147 Major St — HVAC clash mark-up

HVAC Designs LO# 113963 (HVA 26 167838) vs permit 26 167838 BLD 00 · PalmView BIM review · Oct 22, 2026

Two systems: F-1 basement (basement + main floor from below) · F-2 2nd-floor mech room (2nd + 3rd floors from the 3rd-floor joist space).

Sheet Title
BASEMENT HEATING LAYOUT

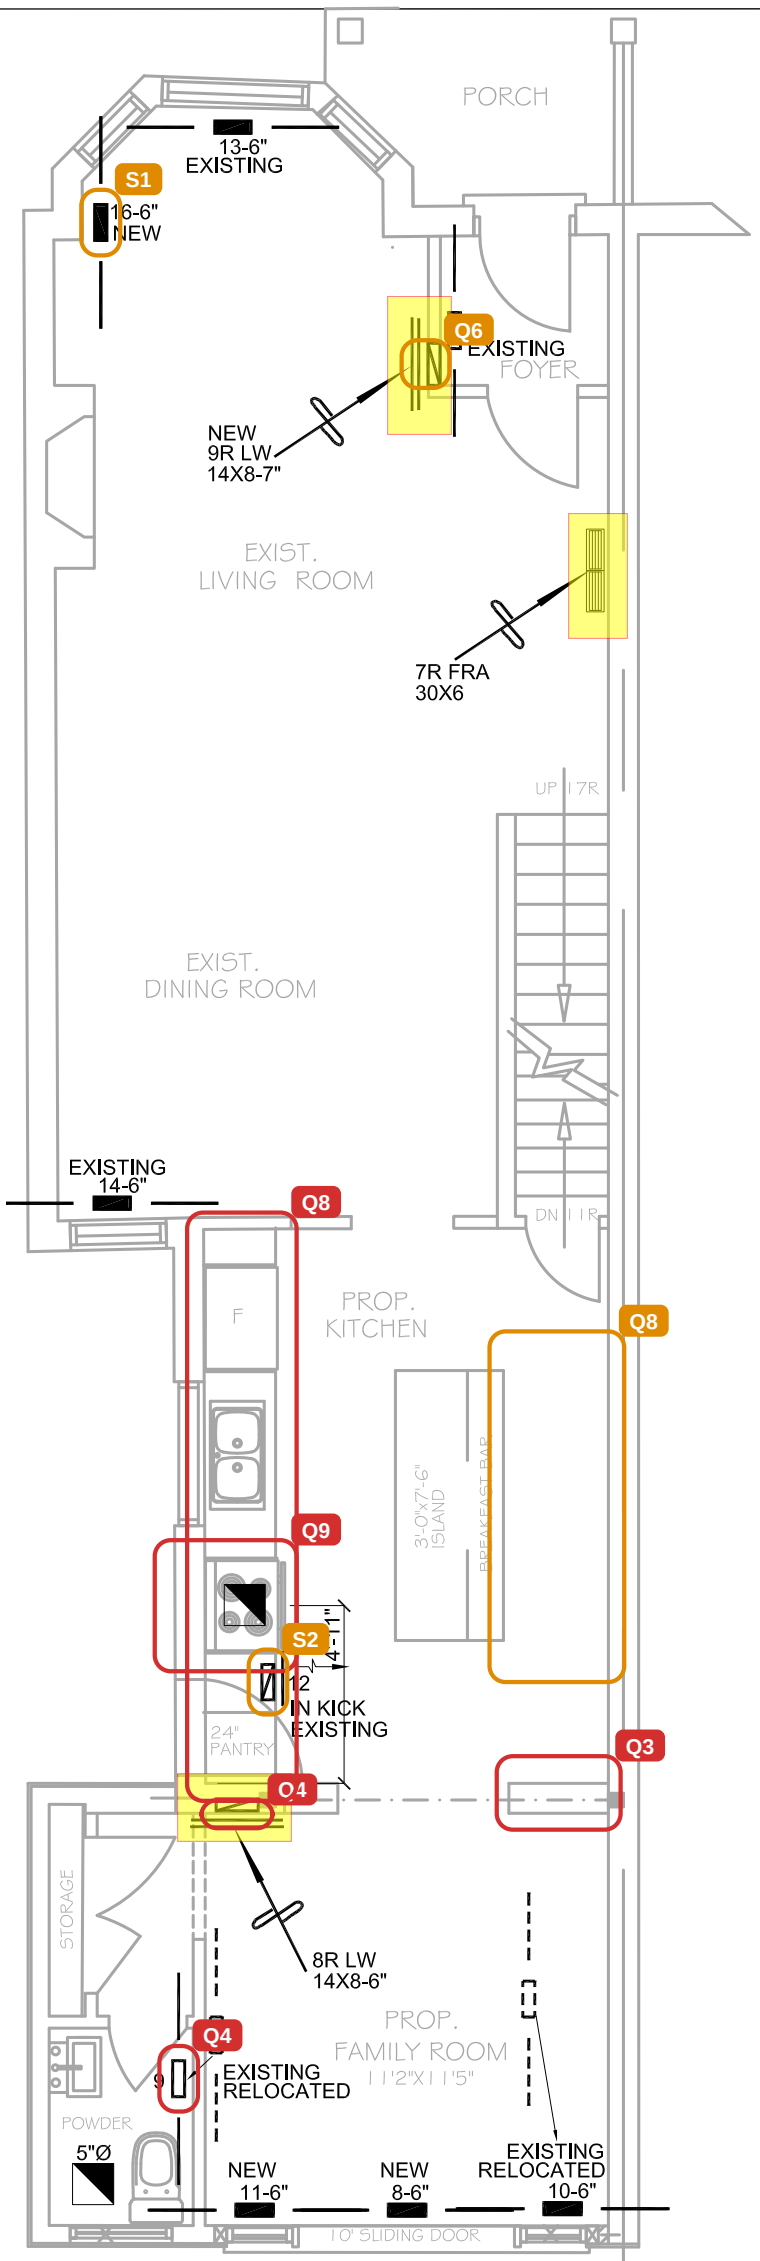
Q3 Rear branches 8, 10, 23 through the old rear foundation

Q4 Supply 9 and return 8R sit on old foundation walls

Q6 7" return stacks in 2x4 walls (1R–6R, 9R) and 6" supply stacks

Q10 F-1 new or existing; hot water tank vs plenum

S3 Trunk E ends ½" off the old rear wall

Sheet Title
FIRST FLOOR HEATING LAYOUT

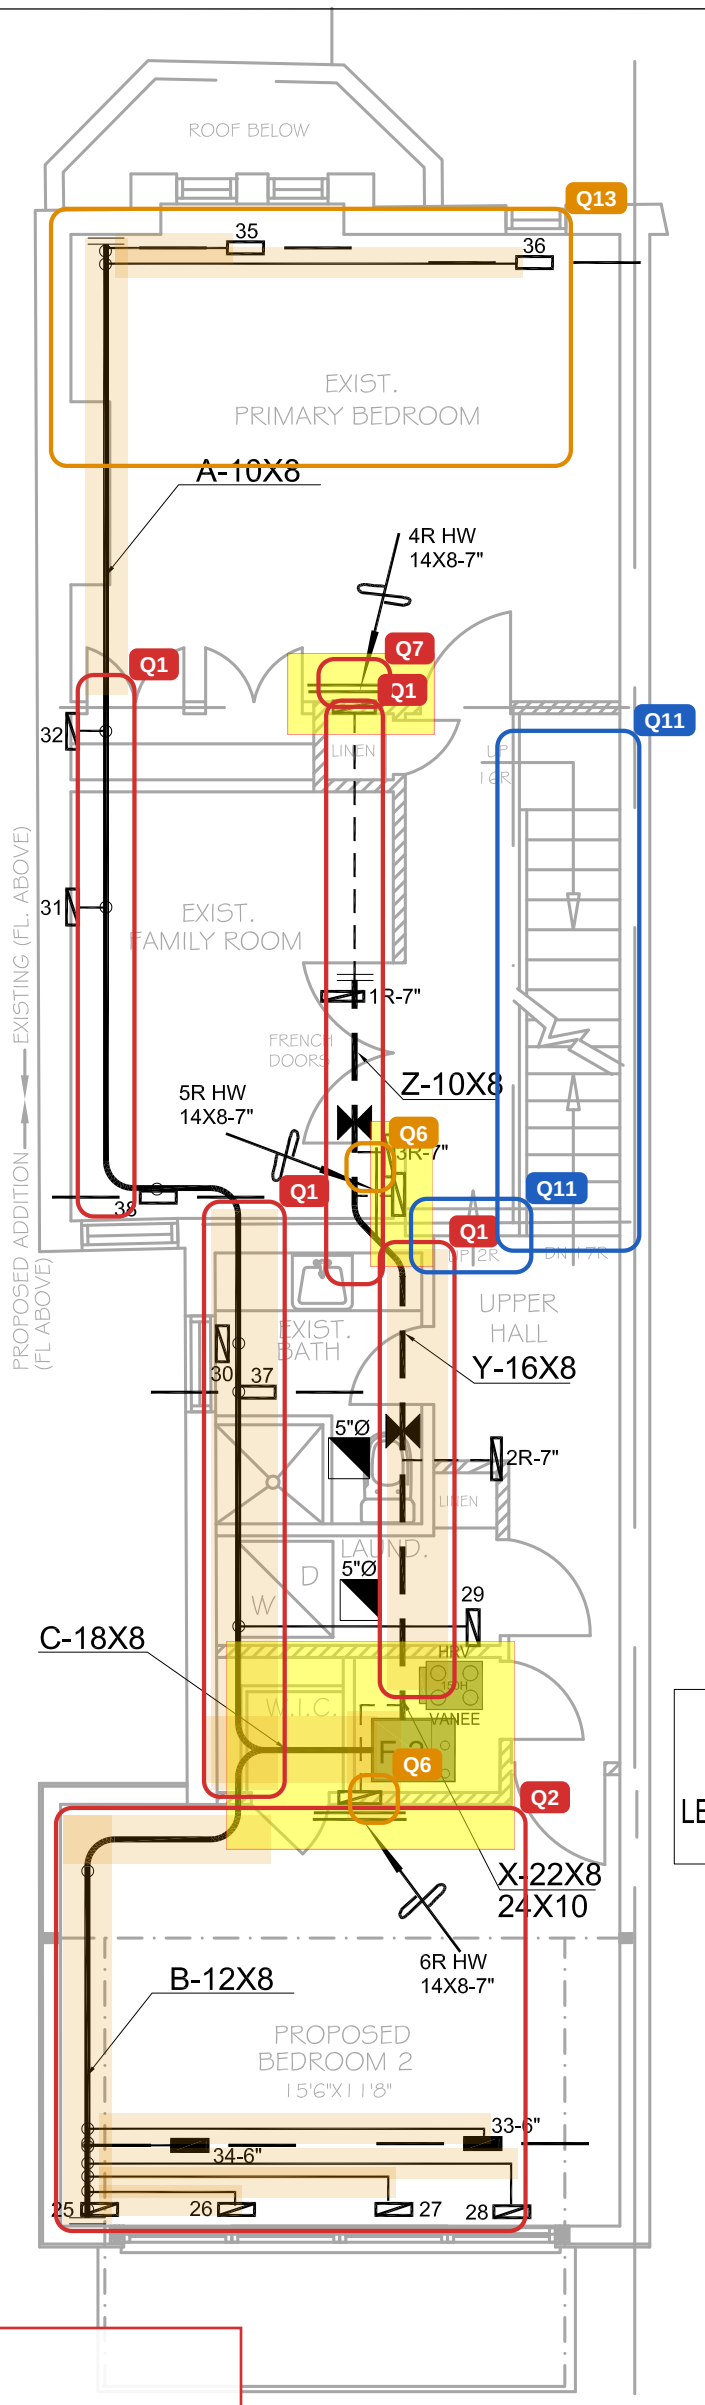
- Q3 Rear branches 8, 10, 23 through the old rear foundation
- Q4 Supply 9 and return 8R sit on old foundation walls
- Q6 7" return stacks in 2x4 walls (1R–6R, 9R) and 6" supply stacks
- Q8 Kitchen sizes: range, fridge, run length and aisle
- Q9 Kitchen hood exhaust not designed
- S1 Supply 16 boot tight to the bay corner
- S2 Supply 12 kick register under the pantry

Sheet Title
SECOND FLOOR HEATING LAYOUT

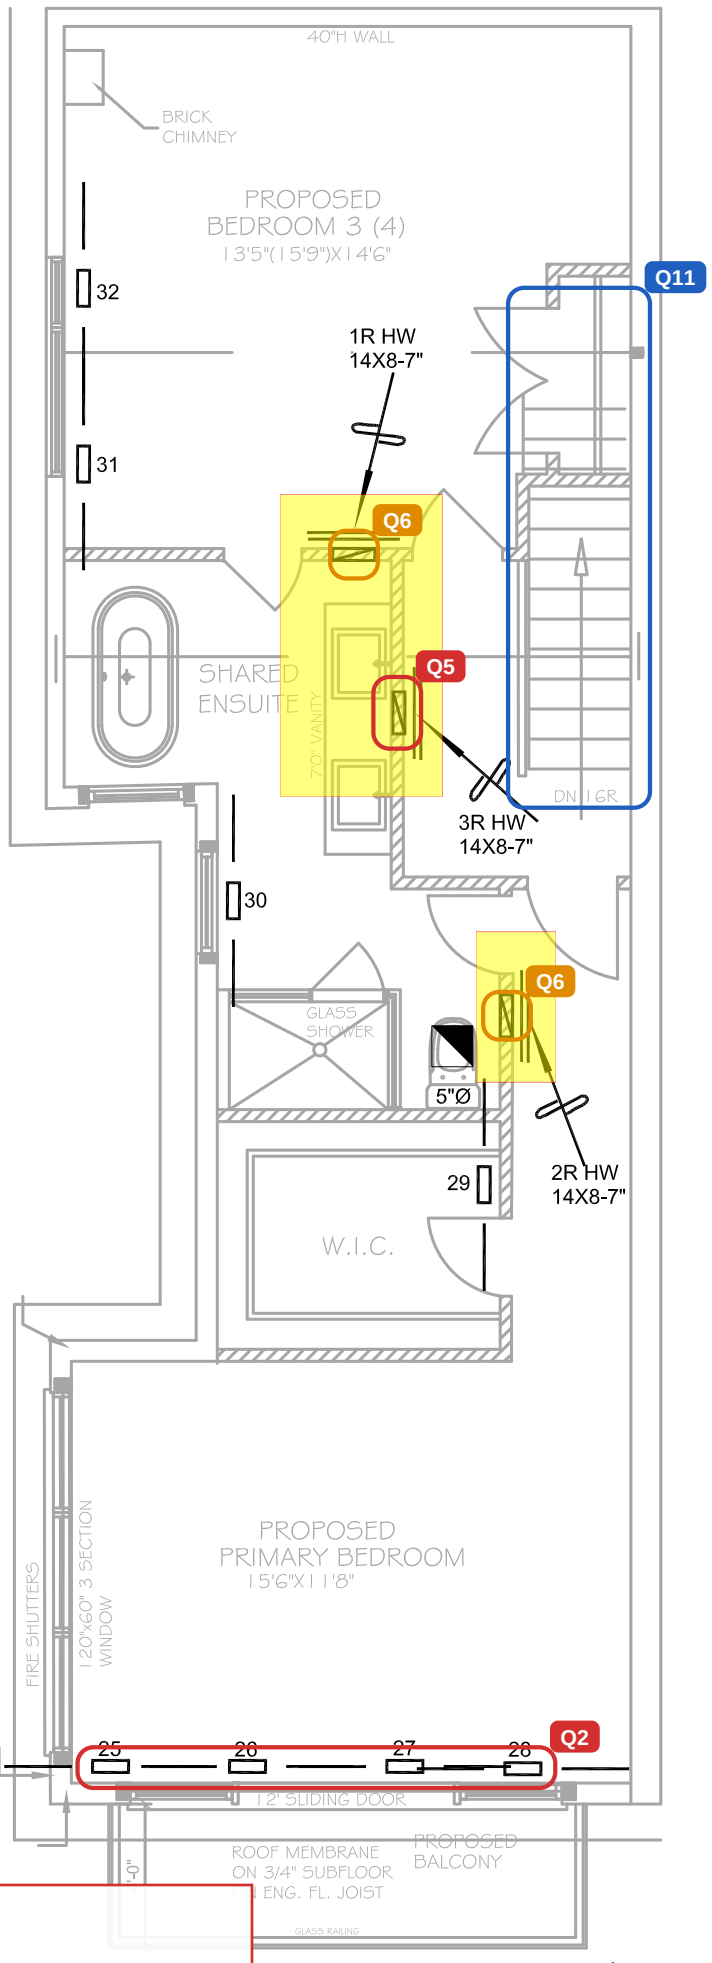
Q1 2nd-floor ceilings for the F-2 trunks

Q2 Bedroom 2 ceiling: joist direction and trunk B on LVL1

Q6 7" return stacks in 2x4 walls (1R–6R, 9R) and 6" supply stacks

Q7 Return 4R stack vs the LVL5 flush beam

Q11 Stair direction 2nd → 3rd, and the size of the 2nd-floor step

Q13 Front roof space over the primary bedroom
